RESOLUTION 2013-47

A RESOLUTION APPROVING A DEVELOPMENT PLAN FOR WATER'S EDGE PUD SUBDIVISION, LOCATED AT 4413 SOUTH CAROTHERS ROAD, BY THE CITY OF FRANKLIN, TENNESSEE.

FRANKLIN MUNICIPAL PLANNING COMMISSION REPORT

NAME OF PROJECT: Water's Edge PUD Subdivision, development plan
LOCATION: 4413 South Carothers Road
PROJECT DESCRIPTION: 213 single family units and 123 townhome units on 195.5 acres
APPLICANT: Greg Gamble
OWNER: Jack Ludington, Goodall Homes
PROJECT STAFF: Emily Hunter
TYPE OF REVIEW: Development Plan
RECOMMENDATION: Favorable Recommendation to BOMA

FLOODPLAIN

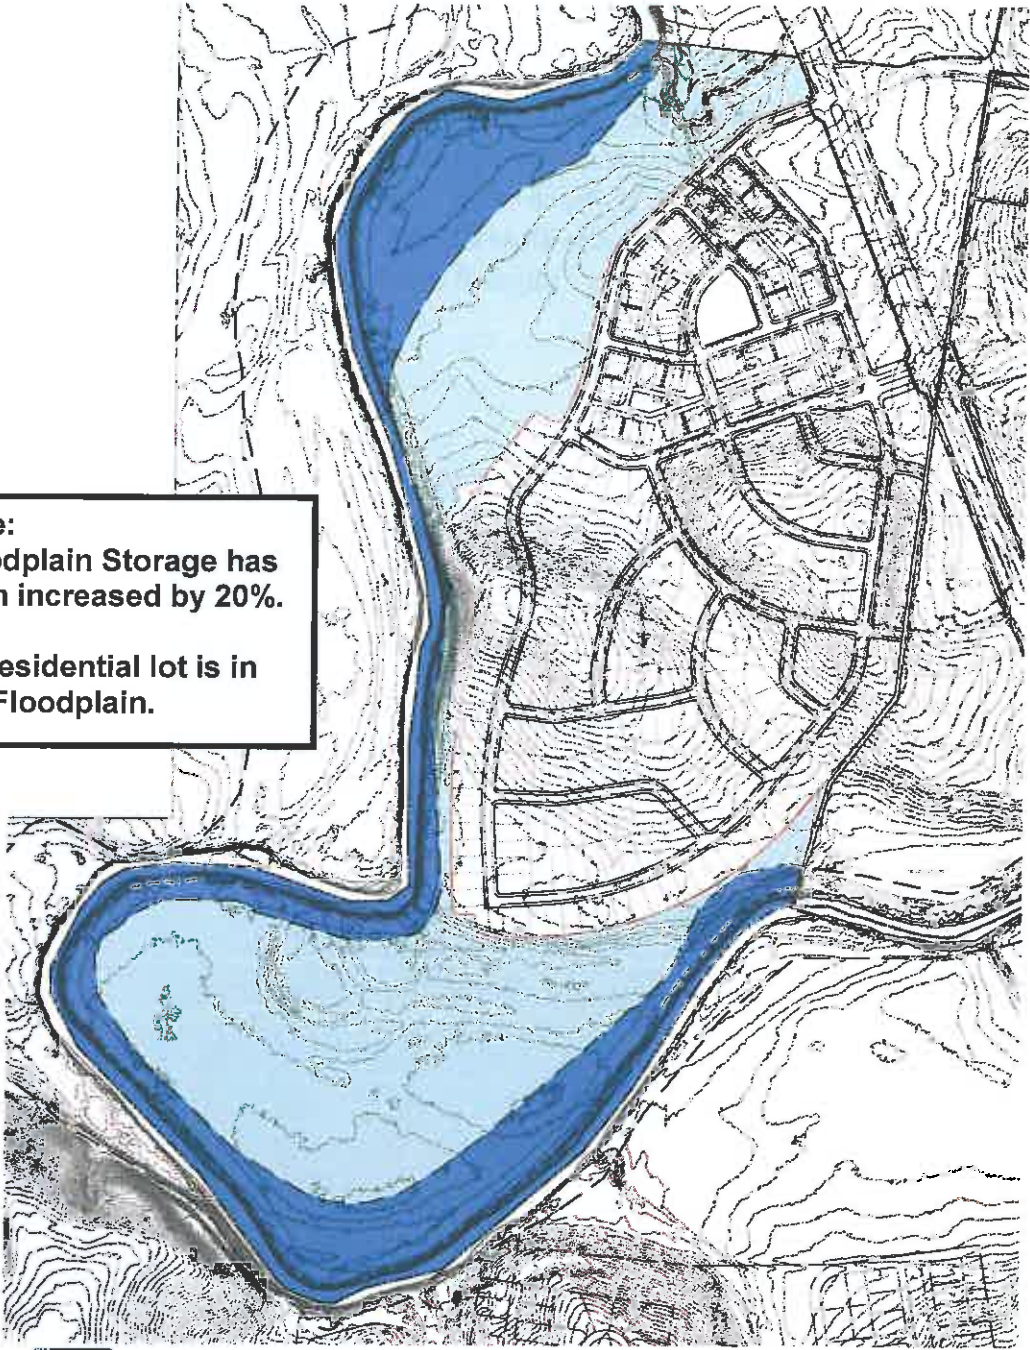
COMMENTS: This development plan is proposed with 213 single family residential units and 123 attached townhome units. The Harpeth River borders the site to the west and south. Much of the proposed development lies within existing floodplain, which the applicant proposes to alter with cut and fill. Since significant portions of the site are proposed for floodplain alteration, the applicant has included a Floodplain Alterations and Enhancements document that provides justification for the extent of the floodplain alteration. Planning Commission and BOMA should carefully consider the impact of this development within the existing floodplain. The Land Use
